# **INFORMATION MEMORANDUM**

SUBJECT: Consider approving Resolution No. 2020-126 for a Detailed Site Plan amendment for an attached single-family development on an approximately 0.75-acre lot located at 2620 Valley View Lane; and take appropriate action.

### ***Special Exception #5 – Section I.J.6.***

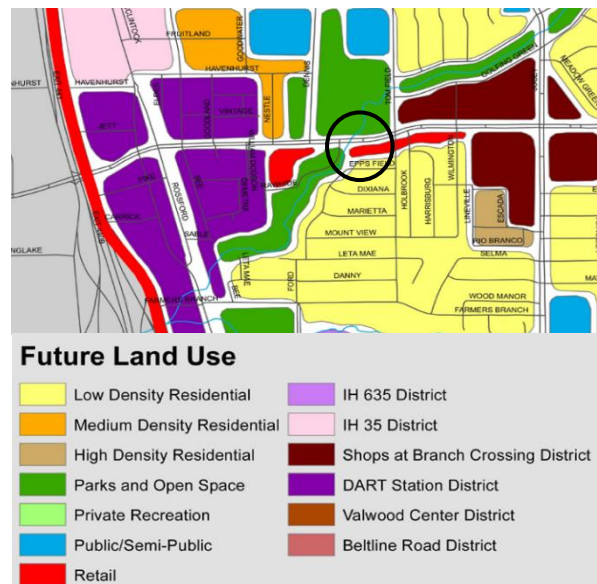
PD-93 requires that an 8-foot sidewalk be installed along Valley View Lane.

The applicant is seeking approval of a special exception to allow for reduction in the width of the sidewalk to four feet. The applicant has expressed concern that the proposed 4-foot sidewalk would be consistent with the sidewalks along Valley View Lane and would avoid the need to relocate an existing fire hydrant and electrical pole located within the right-of-way.

Staff believes that the requested special exception is not appropriate given that the 4-foot sidewalk is located back-of-curb to Valley View Lane. Valley View Lane is a six-lane divided arterial street that carries high traffic volumes. The proposed sidewalk will connect this development with the existing public park and Station Area to the west. Therefore, the sidewalk should encourage pedestrian traffic and walkability. At the time this property was rezoned in 2008, the Station Area Code and the city's goals for urban development based on pedestrian and transit-oriented development principles were already in place, hence the requirement for the 8-foot wide sidewalk. The existing fire hydrant and utility pole were known conditions prior to the development of the property.

On August 31, 2020 the Planning and Zoning Commission considered this request and approved all requested special exceptions with the exception of Special Exception #5 related to the reduction to the required 8-foot sidewalk along Valley View Lane, and that the applicant be required to install a minimum 6-foot sidewalk along Valley View Lane and work with staff regarding the potential relocation of the fire hydrant and electric pole. Additionally, the Commission recommended to approve the Detailed Site Plan as described in Resolution No. 2020-126 (inclusive of the approved special exceptions).
